The Sizewell C Project

8.1 Main Development Site Design and Access Statement Addendum

January 2021

Figure 2.12: Visualisation of Pillbox Field proposals

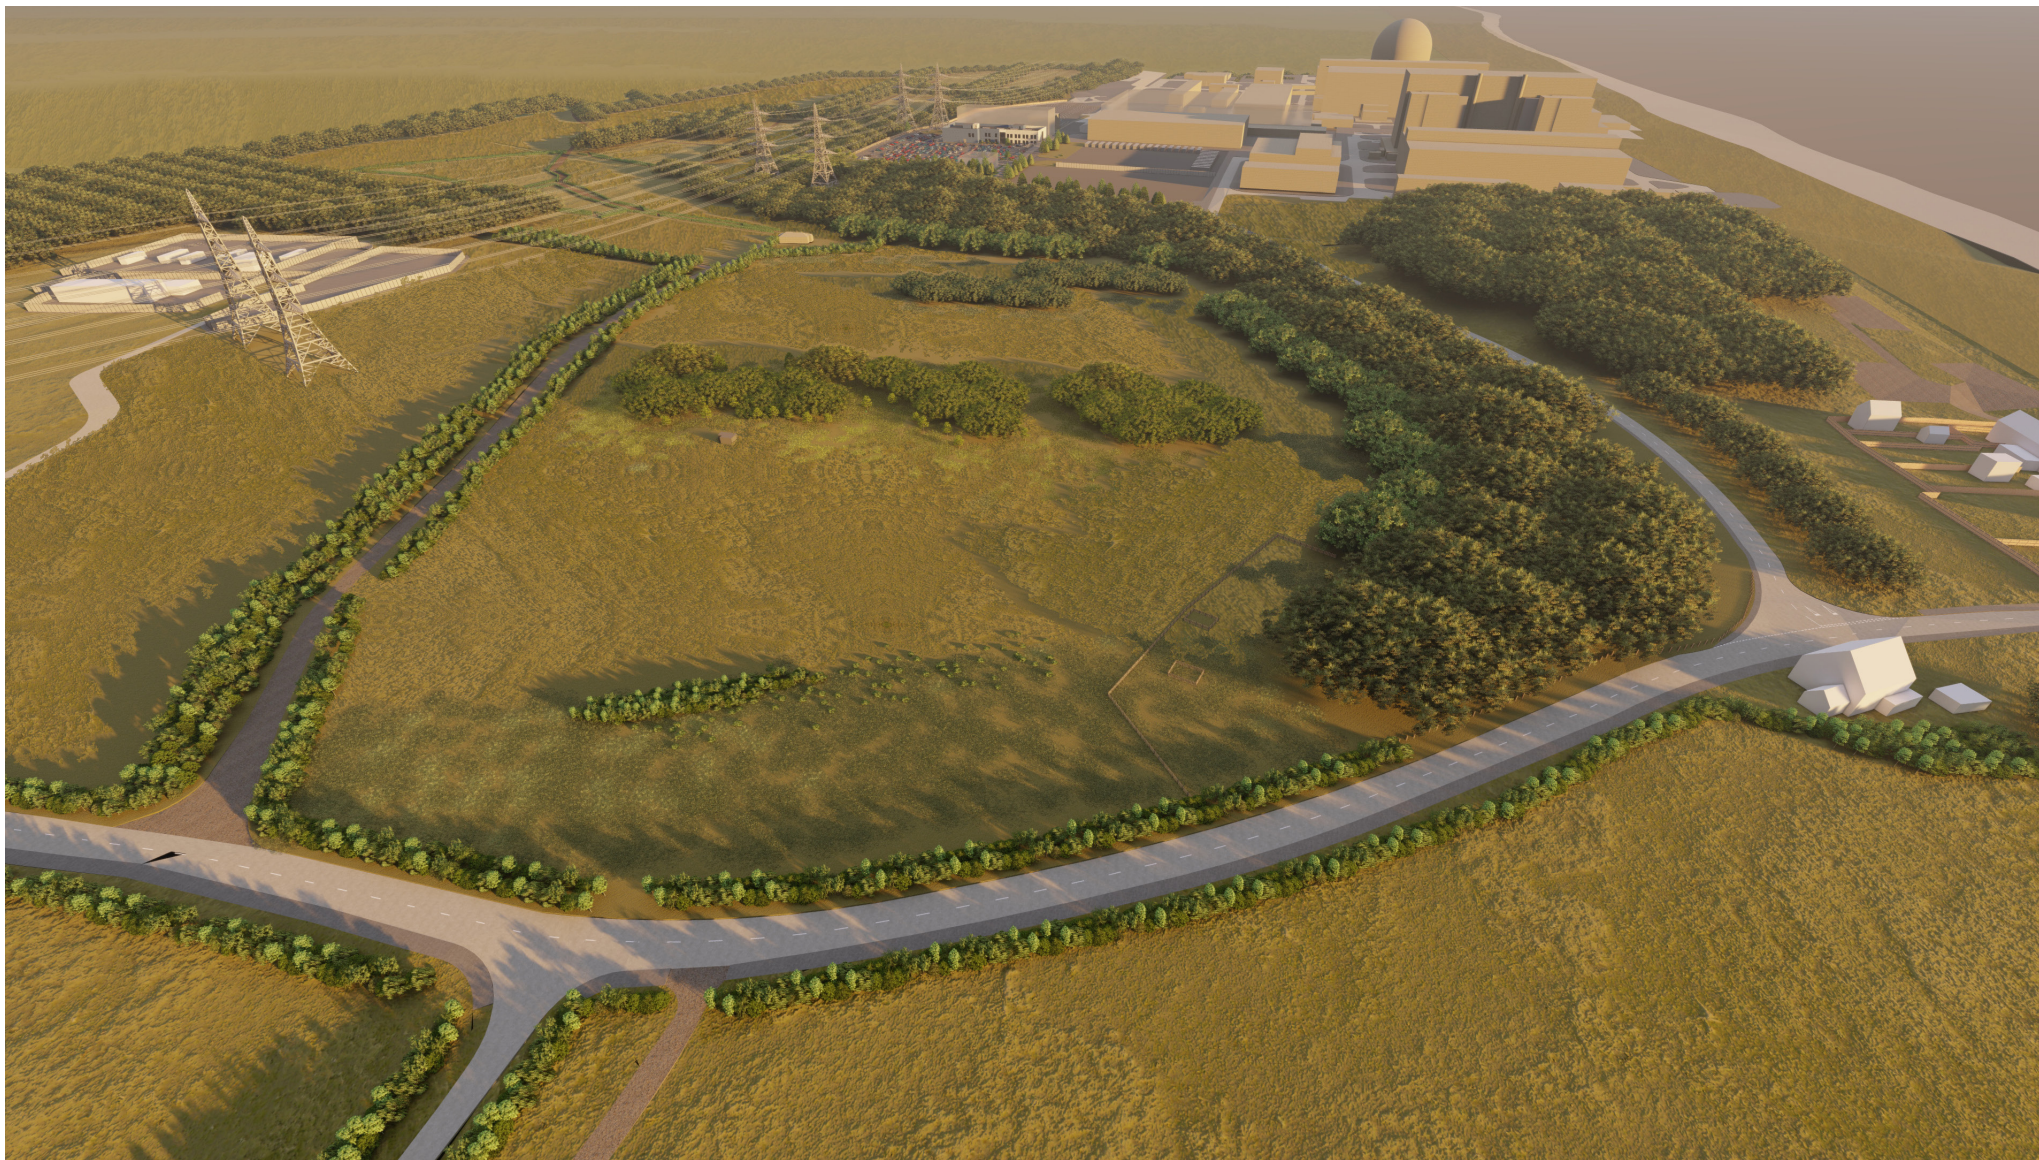
- 2.10.3 The revised landscape proposals for Pillbox Field would provide ecological enhancement and mitigation planting for trees lost from Coronation Wood while preserving the setting of the pillbox (a locally important heritage asset) and supporting the broader masterplan vision for the Sizewell Estate.
- 2.10.4 One hectare of new woodland and woodland edge planting is proposed within Pillbox Field and provides replacement planting for the loss of Coronation Wood. Woodland planting also provides enhanced visual screening of the power station infrastructure from Sizewell Gap and Sandy Lane, and increased habitat connectivity.

- 2.10.5 No tree or woodland planting is proposed to the south or directly east of the pillbox in order to preserve the setting of the pillbox and maintain associated sight lines. New hedgerow planting is proposed in several locations along Sandy Lane bridleway and Sizewell Gap to repair gaps within the existing hedgerows and enhance connectivity.
- 2.10.6 Remaining land which is not subject to proposed tree and hedgerow planting comprises existing dry grassland (on slopes and higher ground to the north) and wet grassland and scrub (on lower areas to the south). These areas will be retained as existing and be managed to contribute to and extend areas of acidic heathland in accordance with the wider objectives for the Sizewell Estate. The revised Pillbox Field proposals are shown in **Figure 2.12**.
